Access Compliance Report

Public Rights-of-Way

(Curb Ramps)

Intersection ID: 23329	Main Street: GLENEAGLES_RD	Cross Street: PARK_RD	Location: SW
ADA ID: 45230876C1A6	Ramp Type: PerpDiag	Initial Pass/Fail: Fail	Overall Compliance: No
Severity Score: 35			
Codes/Mitigation Info/Possible Solution		Field Measurements/Component Compliance

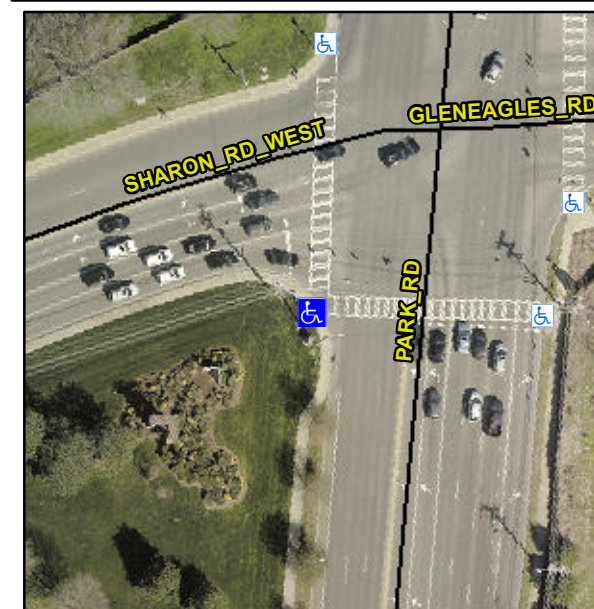
Not Found, R304.5.1

Compliance	Description	Data	Compliance	Description	Data
N/A	Ramp Length (in)	59.0	Yes	Ramp Slope (%)	7.6
No	Ramp Width (in)	30.0	Yes	Ramp XSlope (%)	1.2
N/A	Flare Type LT	N/A	N/A	Flare Type RT	N/A
N/A	Flare Slope LT (%)	N/A	N/A	Flare Slope RT (%)	N/A
N/A	Flare Traversable LT?	N/A	N/A	Flare Traversable RT?	N/A
N/A	Landing Length (in)	N/A	N/A	DWS Provided?	N/A
N/A	Landing Width (in)	N/A	N/A	DWS Contrast?	N/A
N/A	Landing Slope (%)	N/A	N/A	DWS Length (in)	N/A
N/A	Landing X Slope (%)	N/A	N/A	DWS Full Width?	N/A
N/A	Landing Curb? (Y/N)	N/A	N/A	DWS Offset (in)	N/A
N/A	Shared Landing?	N/A			
N/A	Gutter Ponding?	N/A	N/A	Gutter Slope (%)	N/A
N/A	Gutter Lip Ht (in)	N/A	N/A	Gutter X Slope (%)	N/A
N/A	Painted X Walk1?	Yes	N/A	Painted X Walk2?	Yes
	X Walk 1 Direction	To SE		X Walk 2 Direction	To NE
N/A	X Walk 1 Width (in)	108.0	N/A	X Walk 2 Width (in)	110.0
	X Walk 1 Slope (%)	2.3		X Walk 2 Slope (%)	0.6
	X Walk 1 X Slope (%)	2.6		X Walk 2 X Slope (%)	2.9

Remove & Replace Curb Ramp With Two New Directional Ramps or Equivalent.
